# City of Canby

## SITE AND DESIGN REVIEW STAFF REPORT

FILE #: DR 16-04

The applicant is seeking site and design review approval to construct a 4,896 square foot commercial/manufacturing building on a 0.5 acre property at 1400 SE Township Road. The development proposal is intended to serve Rudnick Electric Signs. The site will consist of an office area, sign fabrication shop, fleet service bay, and mezzanine space above the office area for large format printing. The site development is to include a steel clad building with one truck service bay door in the north elevation away from the public street frontage where a screened fenced in area will accommodate a paved service drive with 3 parking spaces and a similar sized gravel storage area to north with gates and three additional parking spaces are proposed directly off of a common shared paved drive that serves four platted lots in this industrial zone platted subdivision.

JOB No. 000001 DRAWN SFD DATE 05-30-16 REVISIONS	SITE PLAN CODE SUMMARY GENERAL NOTES	RUDNICK ELECTRIC SIGNS LLC 1400 S TOWNSHIP ROAD CANBY, OREGON 97013	LANDUSE APPLICATION

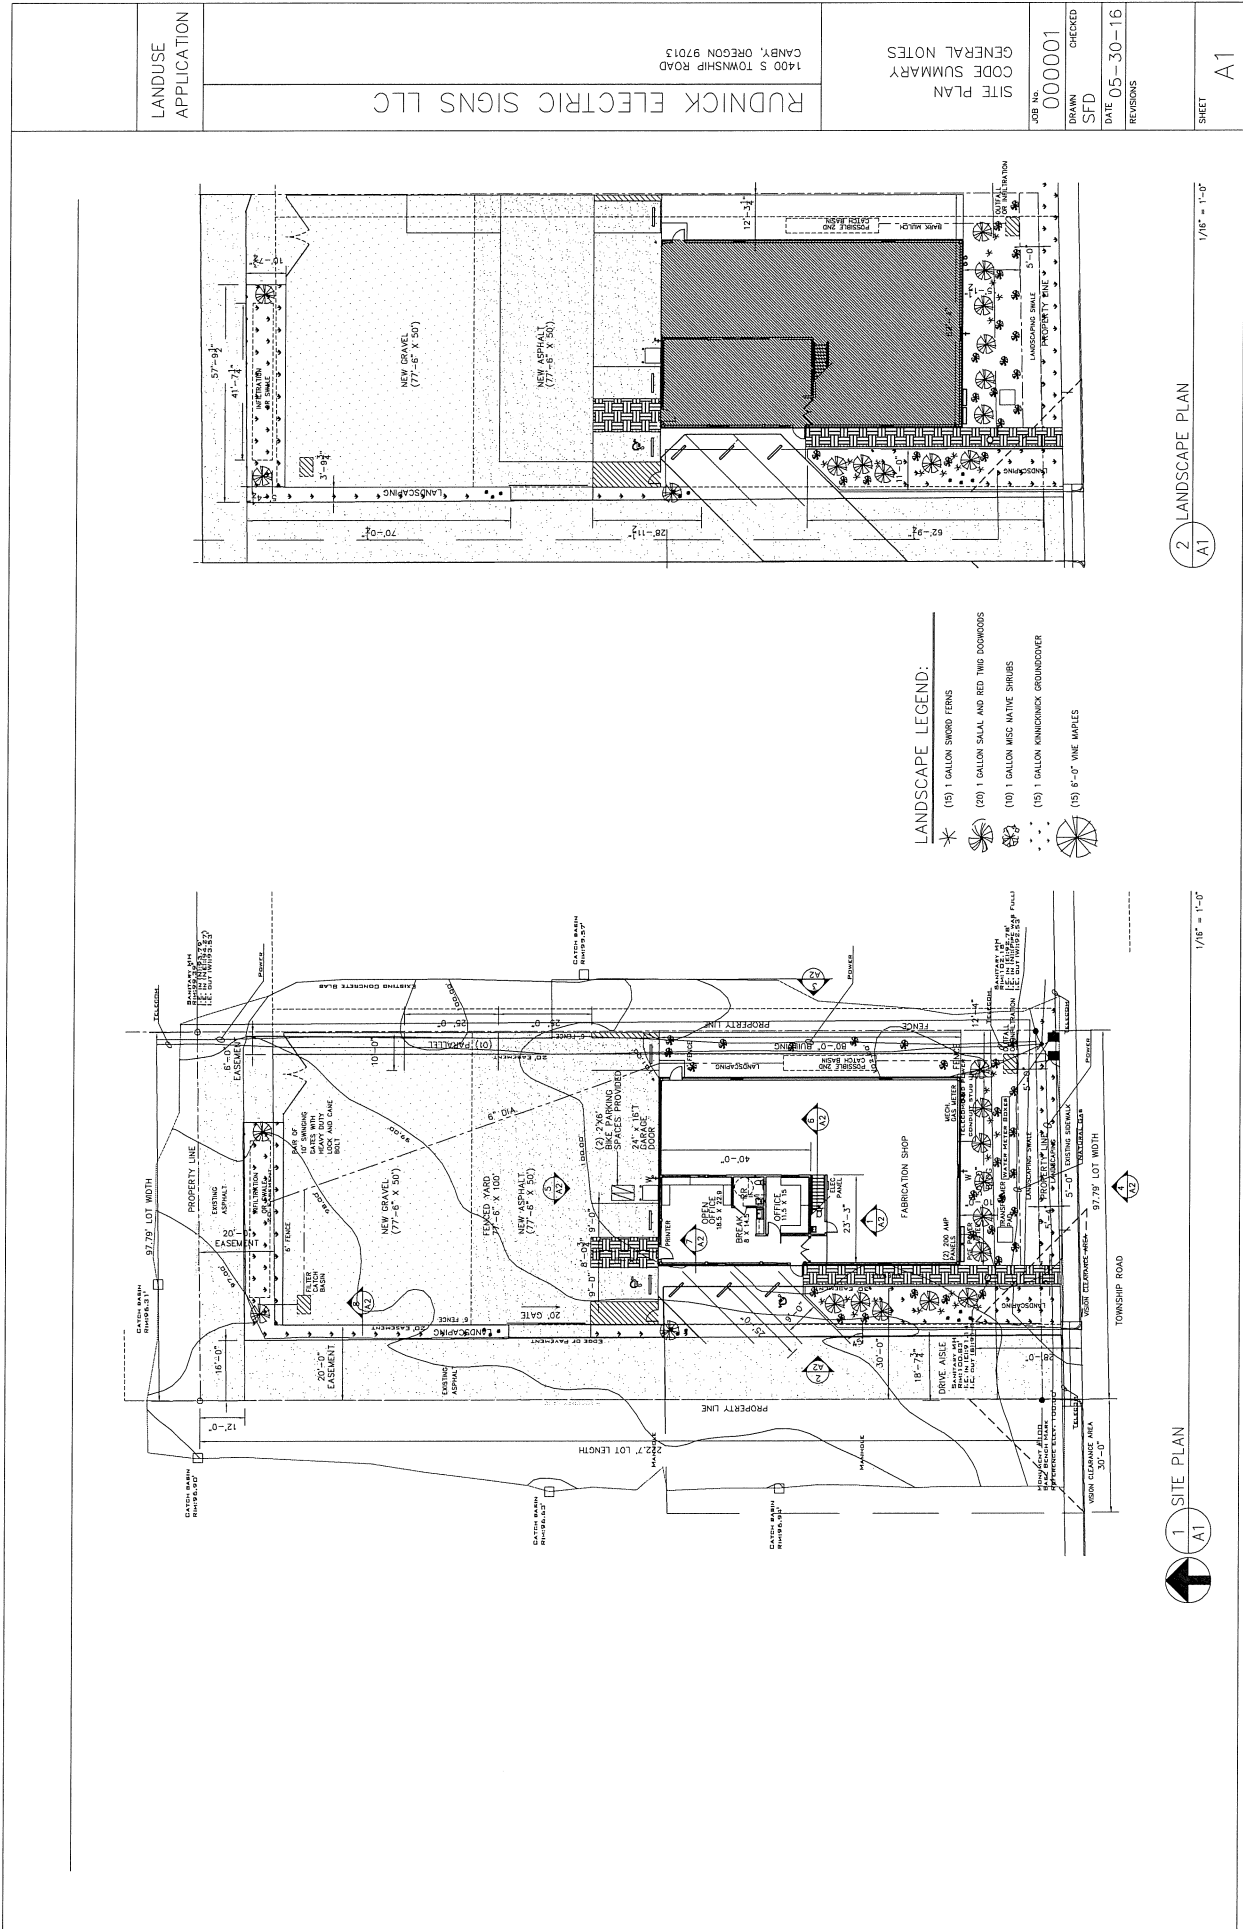
The narrative indicates that 2 bicycle racks are to be provided inside the enclosed fence area just to the north of the building, but their location is not shown on the plan and may be in conflict with the designated parking spaces or electric transformer. A condition of approval will require a revised drawing designating the bike rack location with approval of the final contract approved set of construction drawings.

The applicant provided a response to Table 16.49.040. A generous interpretation of the development's conformance with the necessary point total indicates the project meets the minimum standard. It is not clear what part of the paved parking area is intended to utilize pervious pavement which is necessary to obtain the necessary point total. As a condition of approval, the applicant shall indicate with final construction plan approval that 10 to 50% of the new paved parking area planned to utilize pervious pavement as indicated in the Design Review Point Matrix.

1. A revised site plan shall designate the specific location planned for bike racks with approval of the final construction drawings.
2. The future planned multi-tenant pole or monument sign shall be limited to the size and height standards applicable to a "Minor Business Complex" as indicated in Table 2 of the sign ordinance in recognition of the residential uses directly across SE Township Road from the sign location and shall secure required sign permit approvals separate from this application.

5. Demonstrate on a revised site plan where 10 to 50% of the new paved parking area shall utilize previous pavement.
